Product Safety Recall

N202322235 Seat Belt May Not Be Properly Attached

Release Date: January 2021

Revision: 01

Service Procedure for First Row Outer Seatbelt Retractor Mounting Bolt (Crew Cab Models)

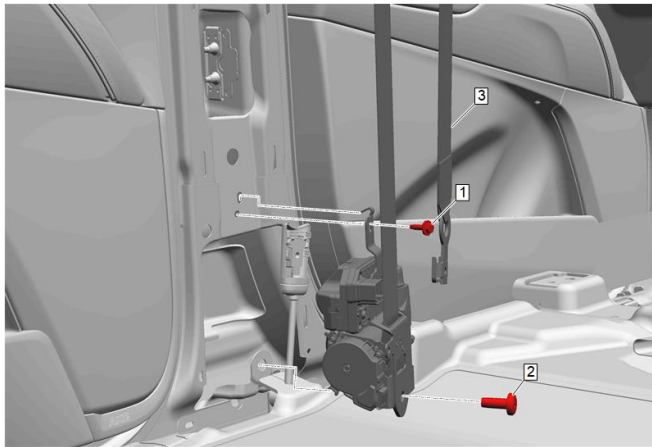
1. Remove the center pillar lower trim panel. It is not necessary to disconnect the seat belt from the seat belt anchor plate tensioner. Refer to *Center Pillar Lower Trim Panel Replacement* in SI.

2. Remove and discard the lower retractor bolt (2).
3. Install the new retractor mounting bolt. Refer to the note above for installation details. Tighten the new service bolt to 45 N.m (33 lb. ft).
4. Reinstall the center pillar lower trim panel. Refer to *Center Pillar Lower Trim Panel Replacement* in SI.

Service Procedure for First Row Outer Seatbelt Retractor and Pretensioner Mounting Bolt (Extended Cab Models)

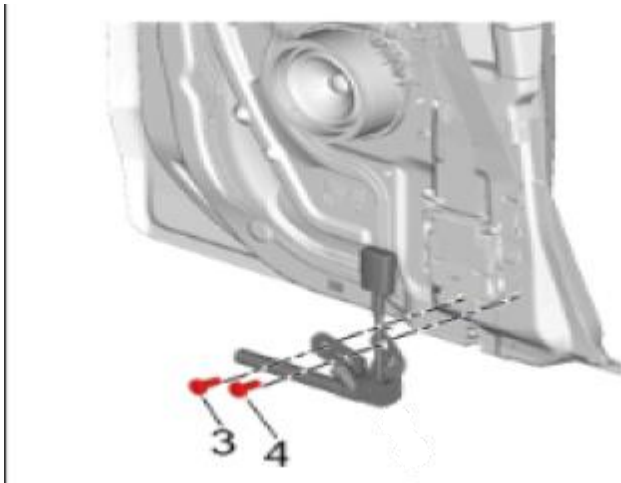
1. Remove the rear side door trim panel. Refer to *Rear Side Door Trim Replacement (Extended Cab)* in SI. It is not necessary to disconnect any seat belt locations.

2. Remove the seat belt retractor (3) and the seat belt anchor plate (4) mounting bolts. Discard the bolts.
3. Install **TWO** new mounting bolts at the seat belt retractor (3) and the seat belt anchor plate (4) locations. Refer to the note above for installation details. Tighten the new service bolts to 45 N.m (33 lb. ft).

Service Procedure for Second Row Outer Seatbelt Retractor and Seat Belt Anchor Bolt Replacement (Crew Cab Models)

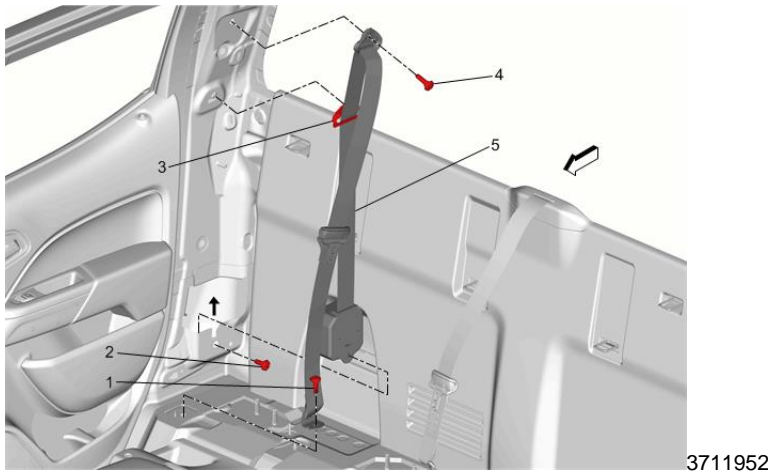
1. Remove the body lock pillar garnish molding. Refer to *Body Lock Pillar Garnish Molding Replacement* in SI.

2. Remove the second-row retractor mounting (2) and seat belt anchor (1) bolt. Discard the bolts.
3. Install **TWO** new mounting bolts at the seat belt retractor (2) and the seat belt anchor plate (1) locations. Refer to the note above for installation details. Tighten the new service bolts to 45 N.m (33 lb. ft).
4. Reinstall the body lock pillar garnish molding. Refer to *Body Lock Pillar Garnish Molding Replacement* in SI.

Service Procedure for Second Row Outer Seatbelt Retractor Mounting Bolt Replacement (Extended Cab Models)

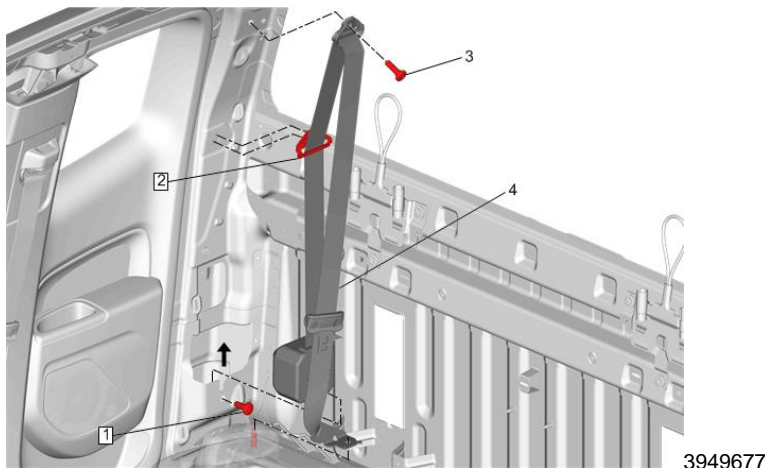
1. Remove the body side rear window garnish molding. Refer to *Body Side Rear Window Garnish Molding Replacement Extended Cab* in SI.

2. Remove the second-row retractor mounting (1) bolt. Discard the bolt.
3. Install the new retractor mounting bolt (1). Refer to the note above for installation details. Tighten the new service bolt to 45 N.m (33 lb. ft).
